Route 6 Hop River Corridor Transportation Study

Andover Stakeholder Workshop

Discussion Notes

Historic Andover Concepts

Historic Andover Village Node Concept 'A'

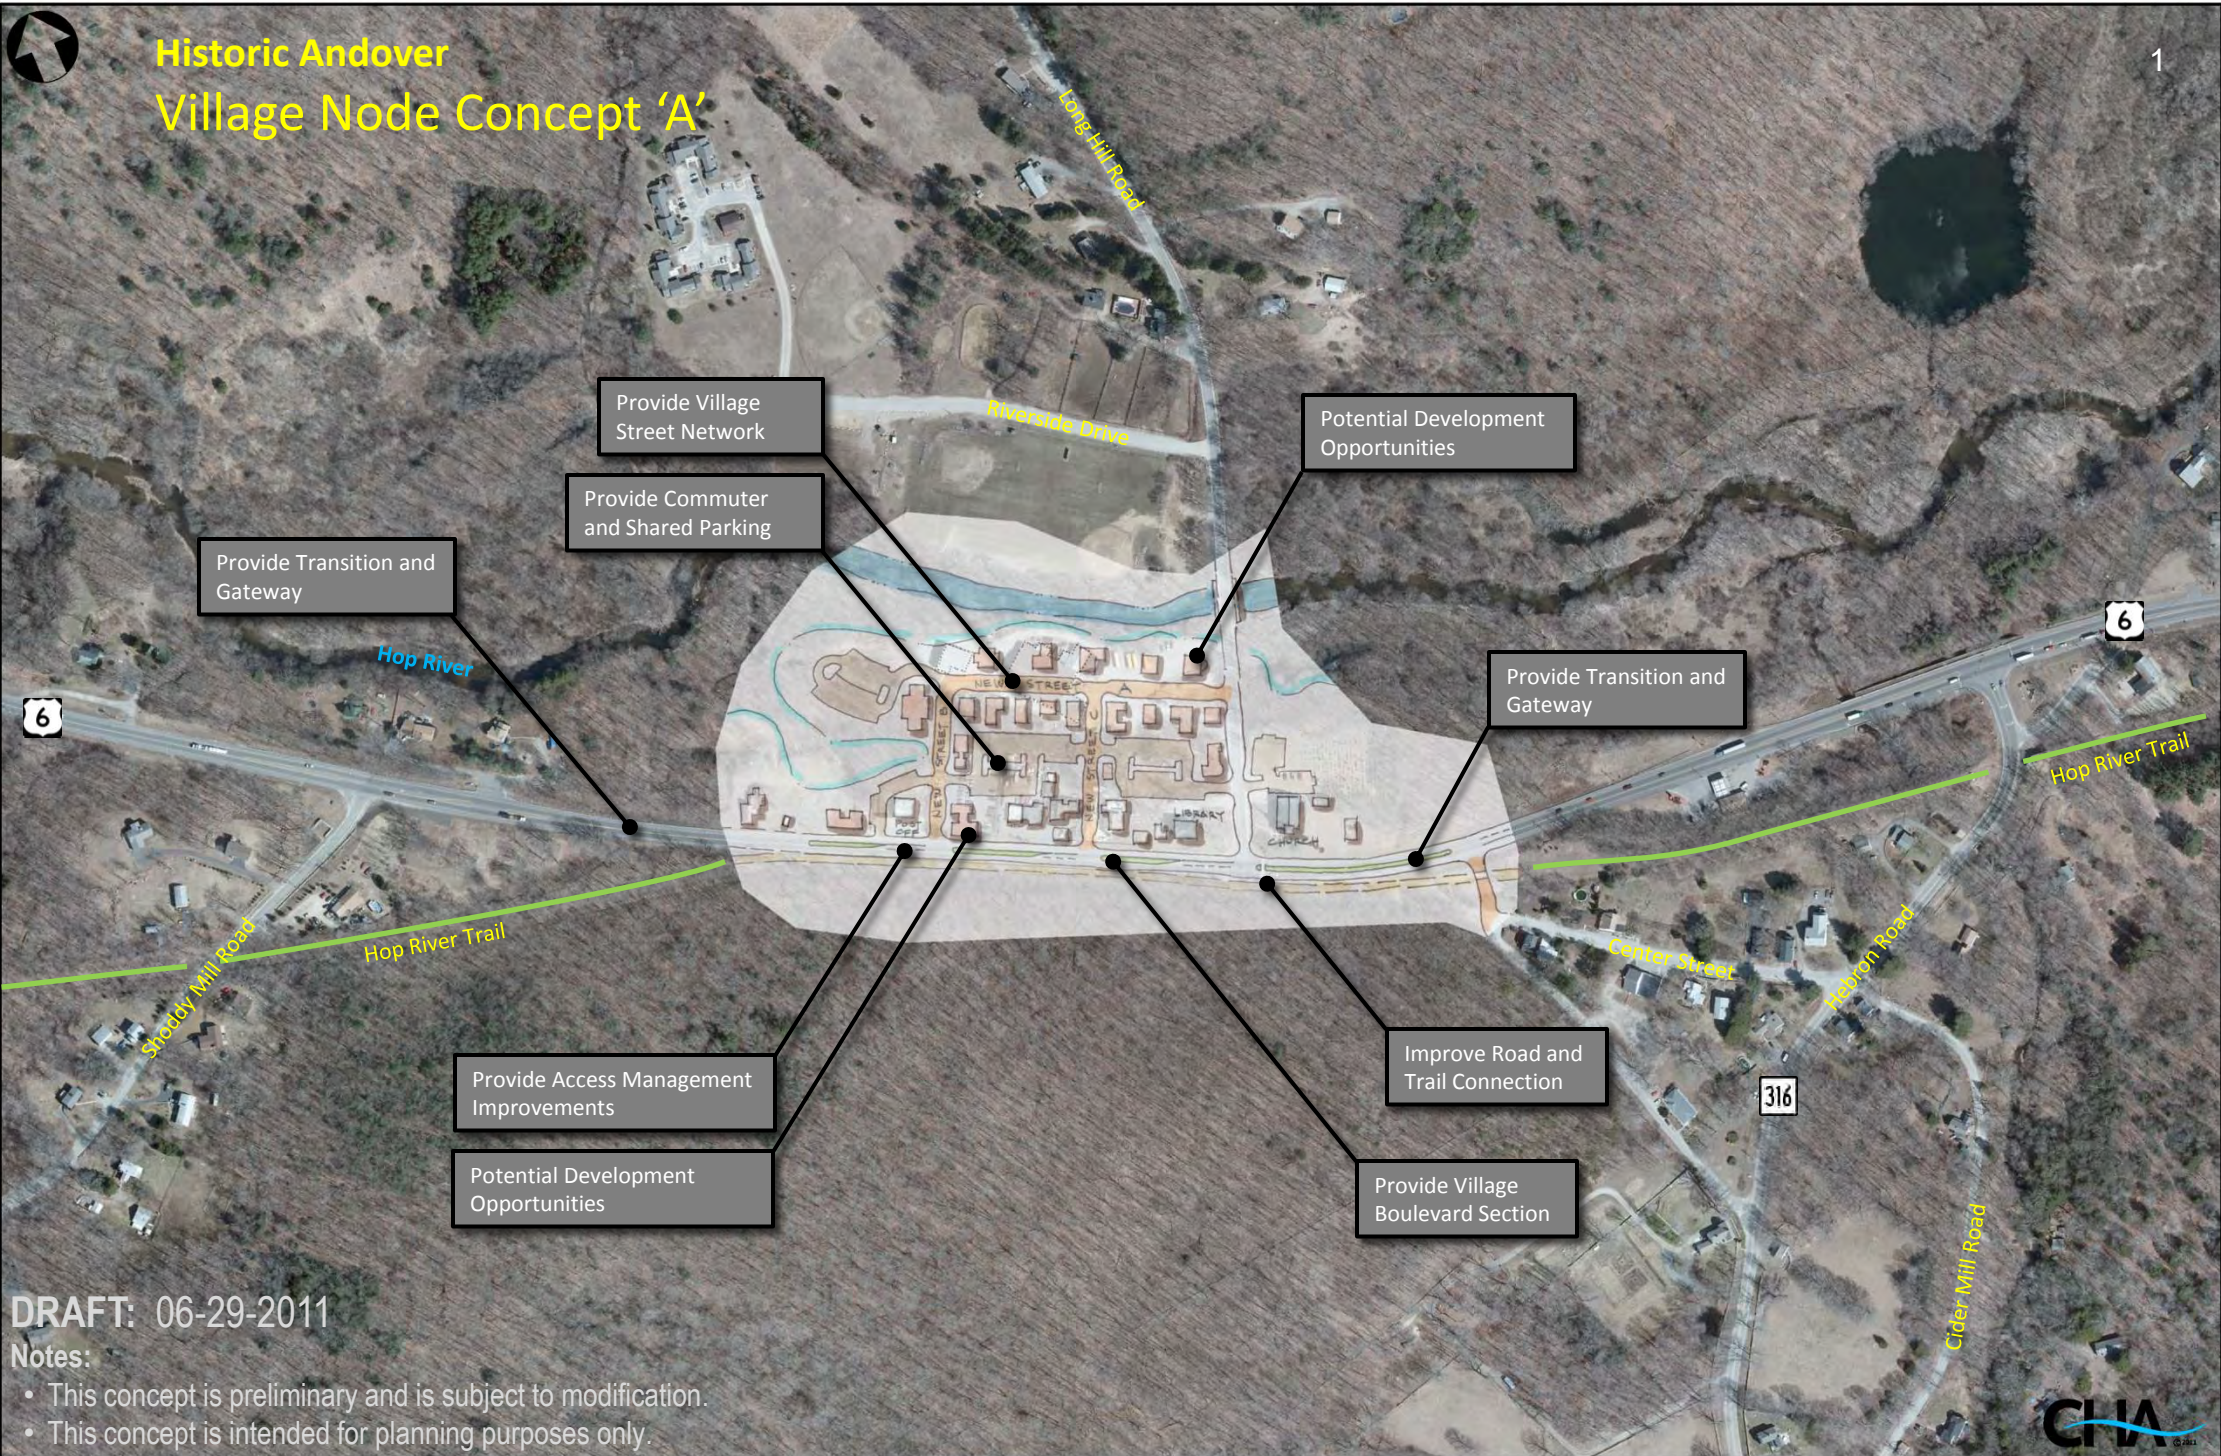
- Sidewalks should be provided in front of the library.
- *Concept A*
 - A cyclist in the group liked the elevated trail because he felt safer and because he felt it is more peaceful being separated vertically from RT 6.

- The group felt that only one really good RT 6 crossing was needed.
 - A bike/pedestrian bridge crossing to the ball fields should be added to this concept (like in Concept B).

- There are a lot of new roads shown in this concept. Do we need this many N-S streets in a small area? “New Street C” could become a bike/ped only street with access to the trail directly across from it (shift crosswalk, place stairs/ramp here). The ball field bike/ped bridge should also be aligned with this street.

- Bob Burbank liked that the businesses have river frontage.
- This concept preserves the scenic views of the river and ball fields.
- **Concept B**
 - Connection to trail is great.

- More support for Concept B than A.
- *Concept A*
 - General feeling that improvements are not significant enough to gather sufficient local support/excitement.

- *General*
 - General support for the “village” development concept.
 - General support for landscaped median along Route 6 in this area.
 - Maintaining access to the Hop River is key.
 - Providing pedestrian access between village and senior housing is important.
- *Concept A*
 - Route 6 would still separate residential streets from new village development.
 - Route 6 would be higher than new village development thus limiting the visibility of this development from Route 6. The group considered this a disadvantage.
 - No general opposition to concept, but feeling of group was that Concept A did not provide enough improvement or opportunity.
- *Concept B*
 - Concept B generally favored by the group over Concept A.
 - Provides better unity between residential streets and village development.

Historic Andover Village Node Concept 'B'

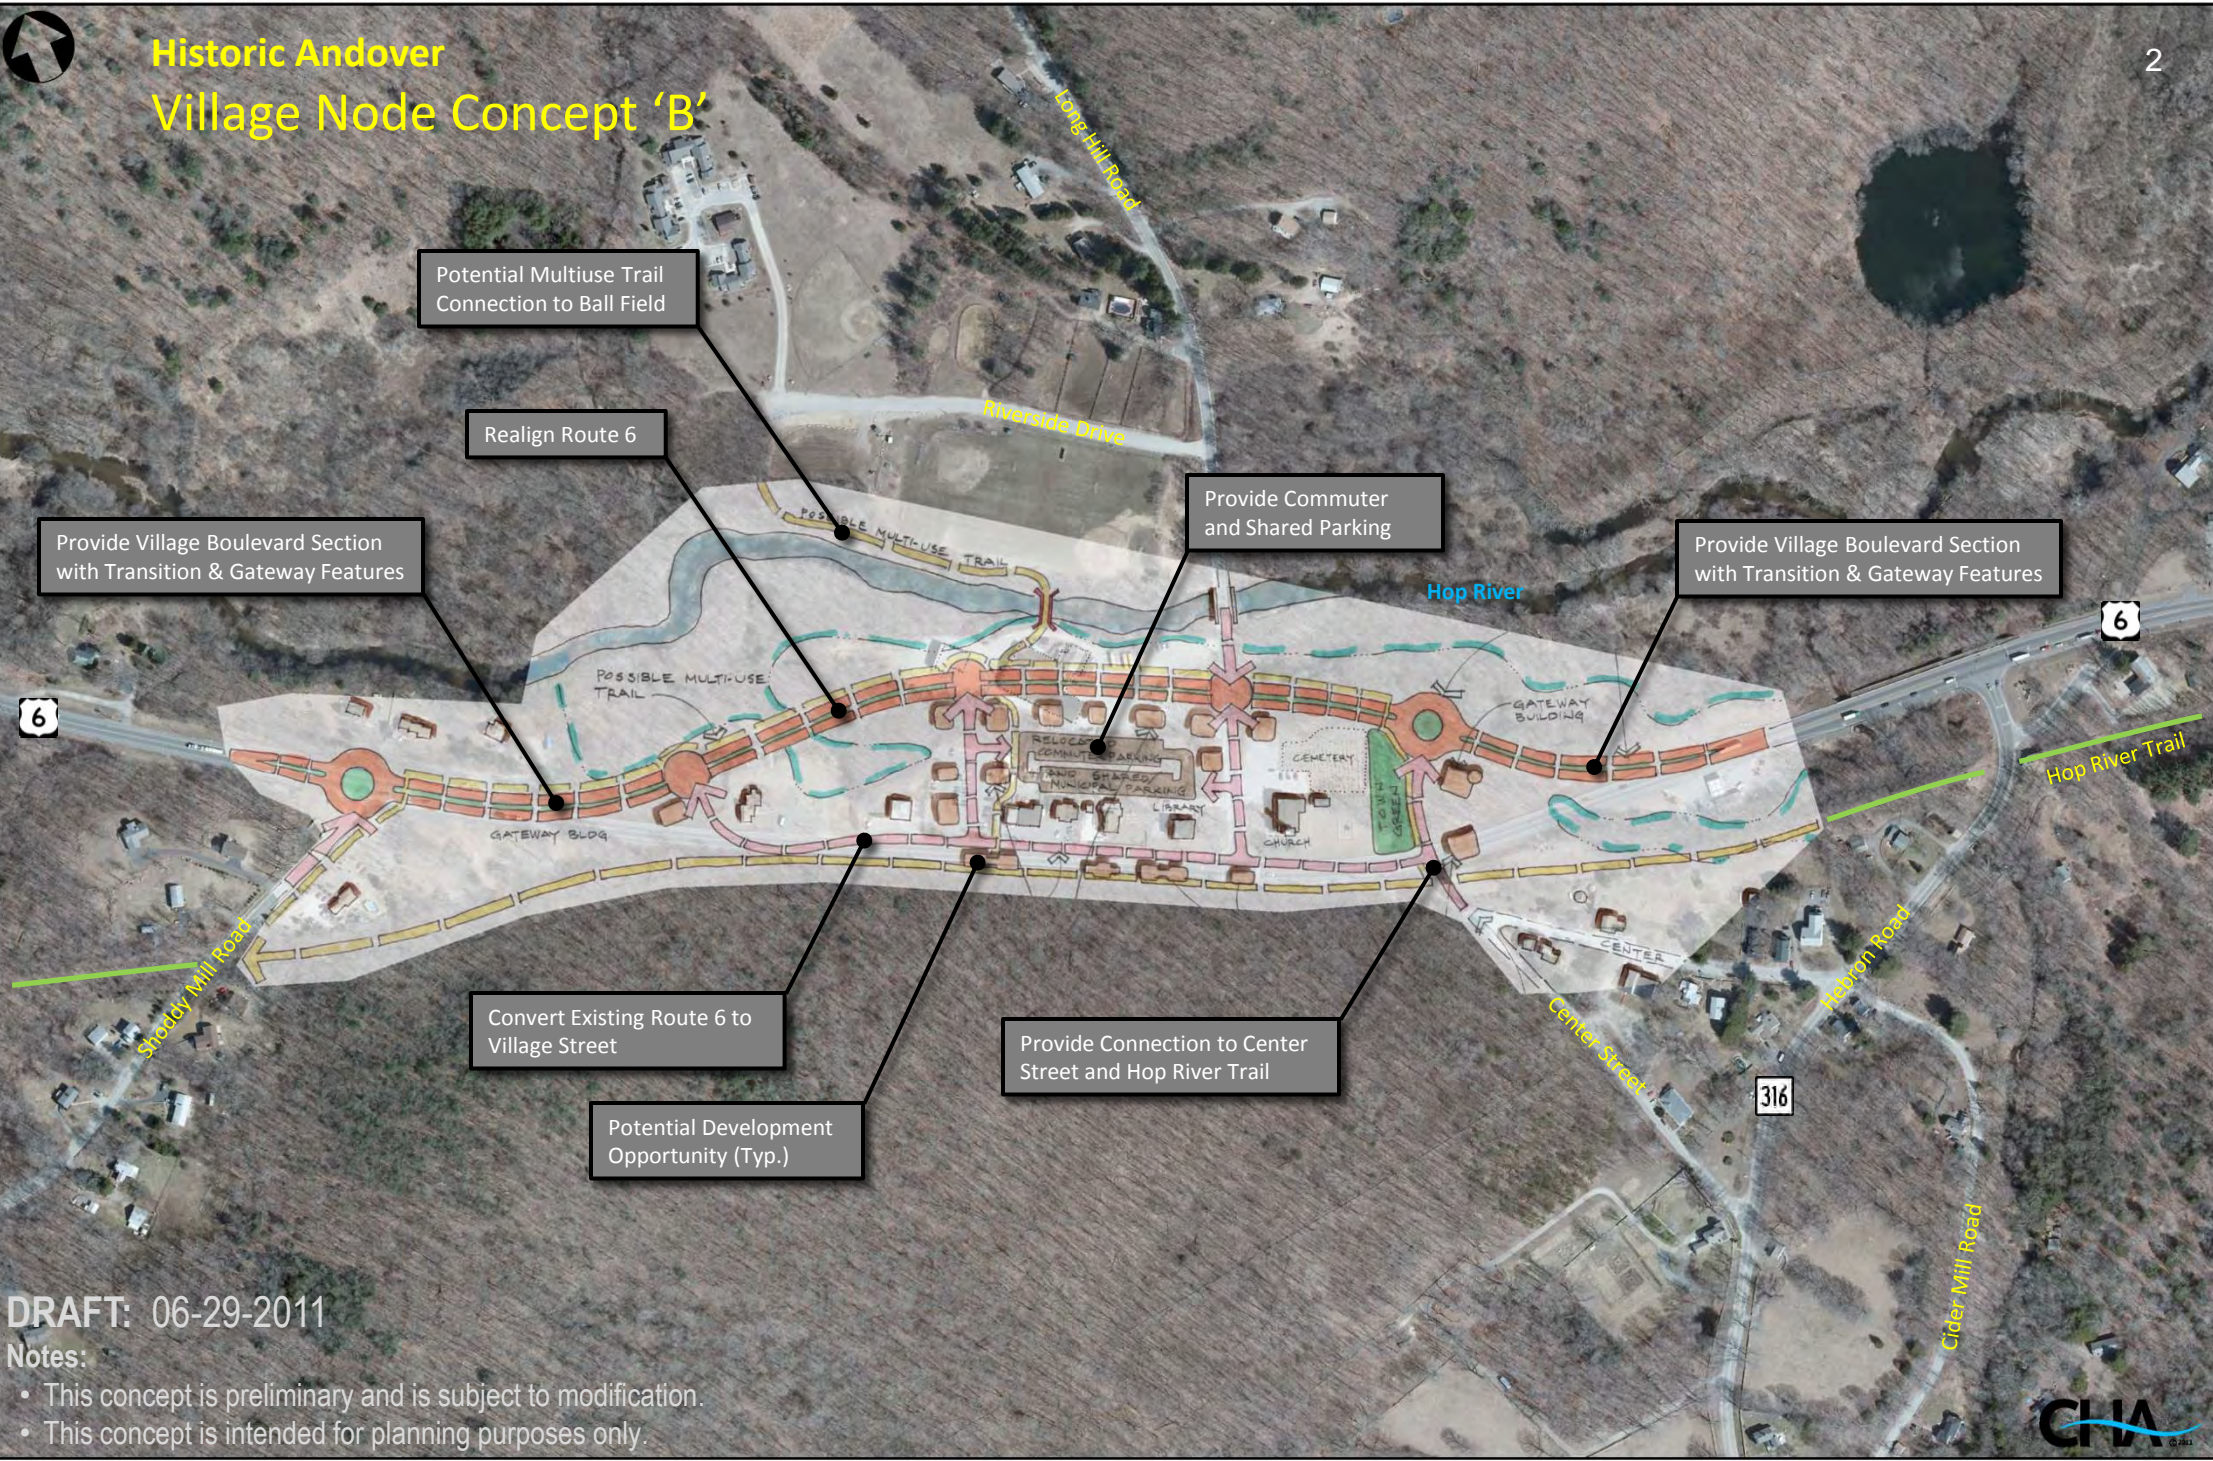
- In Concept B, RT 6 is shown shifted north of its existing placement. An attendee asked if the discussed “village” strategies will also be implemented here. The study team answered that the Historic Andover village node would still be adjacent to RT 6 in its new position so these ideas would still be appropriate.

- Les Giddines really liked Concept B and asked if CTDOT had designed this. It was explained that the study team developed this concept.
- An attendee also liked Concept B since it encourages pedestrian traffic and would support new and existing businesses. This concept also ties in the old historic area and may help revitalize this area with new businesses. Another attendee agreed that the strong connection to the trail would bolster business.

- Like the connection to the ball fields and senior housing; new ball fields are planned for the area west of the existing ball fields – it is good to access these too.

- River is a focal point, placing RT 6 next to this is not desirable.
 - Offers cyclists a choice – trail riding along existing Hop River Trail or along the new trail along RT 6 shown in the sketch.

- The “old”/existing RT 6 could become a very walkable Main Street.
 - Town Green placement is a little odd. The ball field extension planned could serve as an active Town Green. What is shown in the sketch makes sense to keep as green open space/buffer area for the cemetery.

- Alternatives for access to RT 6 & RT 316 are good, but some motorists may use the “old RT6” as a shortcut to get to RT 316 if the connection at Center Street is made.

- Safe crossing of the “new” RT 6 needs to be provided (bridge or tunnel would be nice) to connect to ball fields and senior housing.

- *Concept B*
 - Support for relocating Route 6 (and associated traffic) out of historic district. Concern that there is not enough space between the cemetery and River for the relocation. Concern regarding wetland impacts associated with new alignment. One participant thought that the concept too aggressive (overkill).

- Support for reconnection of “historic district” (Center Street area and Route 6 area).
 - Support for a Town Green concept although thought that it should be moved more towards Center Street with the Hop River Trail running through it.

- Eliminate development along north side of trail (between trail and existing Route 6).
 - Eliminate direct connection east of Long Hill Road from Center Street to relocated Route 6 (thought that would create too much Route 6/Route 318 “cut through” traffic) by realigning the Center Street connection to the existing Long Hill Rd/ Route 6 intersection. Add development along the realigned connection.

- Route 6 would separate the village from the river, which was considered a disadvantage, but safe pedestrian crossings can help mitigate this concern.
- Route 6 would be located lower than new village development and would create better visibility of the village from Route 6.
